SUBJECT: ST. LUCIE UNIT 1 - ISSUANCE OF AMENDMENT RE: REDUCTION
OF REACTOR COOLANT SYSTEM DESIGN FLOWRATE (TAC NO. M86064)

AMENDMENT NO. 130 TO FACILITY OPERATING LICENSE NO. DPR-67 - ST. LUCIE, UNIT 1

Amendment No. 130
License No. DPR-67

SAFETY EVALUATION BY THE OFFICE OF NUCLEAR REACTOR REGULATION

FIGURE 2.1-1 REACTOR CORE THERMAL MARGIN SAFETY LIMIT -
FOUR REACTOR COOLING PUMPS OPERATING

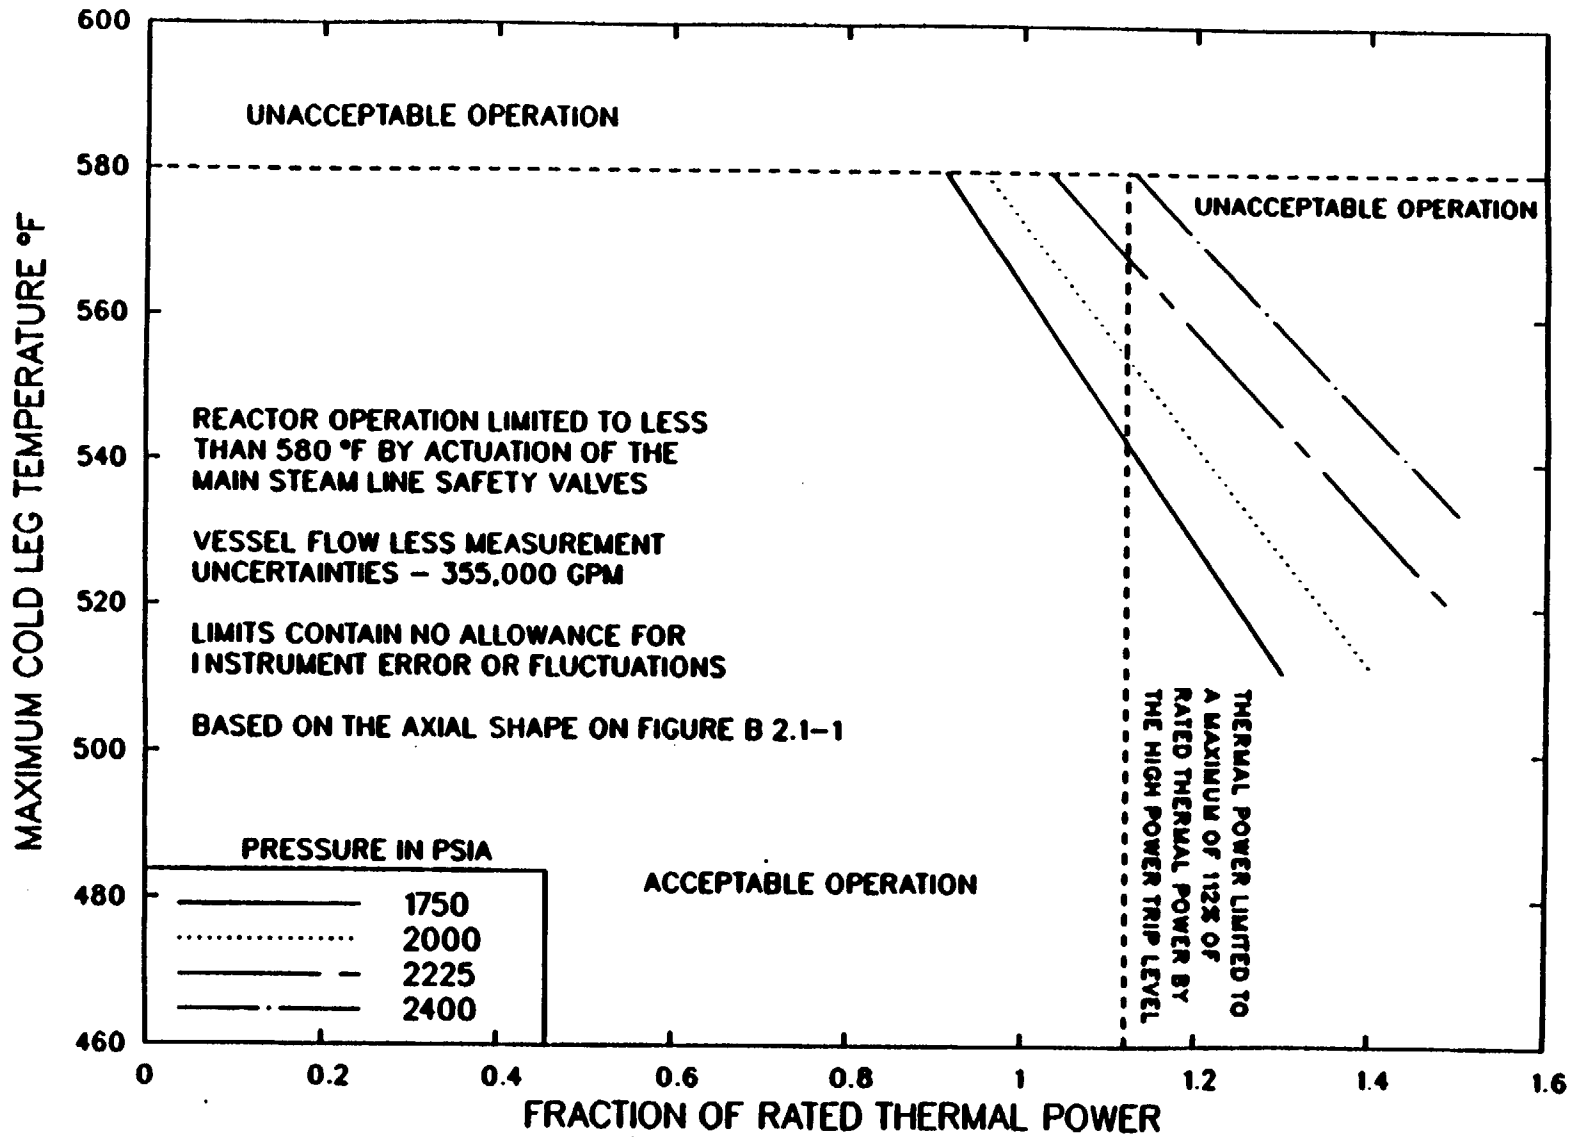
This amendment allows a reduction in Reactor Coolant System design flowrate from the current value of 370,000 gpm to 355,000 gpm in Technical Specifications Figure 2.1-1, and Tables 2.2-1 and 3.2-1 and the associated Bases.

The curves of Figure 2.1-1 show the loci of points of THERMAL POWER, Reactor Coolant System pressure and maximum cold leg temperature with four Reactor Coolant Pumps operating for which the minimum DNBR is no less than the DNBR limit for the axial shape shown in Figure B 2.1-1. The limits in Figure 2.1-1 were calculated for reactor coolant inlet temperatures less than or equal to 580°F. The dashed line at 580°F coolant inlet temperature is not a safety limit; however, operation above 580°F is not possible because of the actuation of the main steam line safety valves which limit the maximum value of reactor inlet temperature. Reactor operation at THERMAL POWER levels higher than 112% of RATED THERMAL POWER is prohibited by the high power level trip setpoint specified in Table 2.1-1. The area of safe operation is below and to the left of these lines.
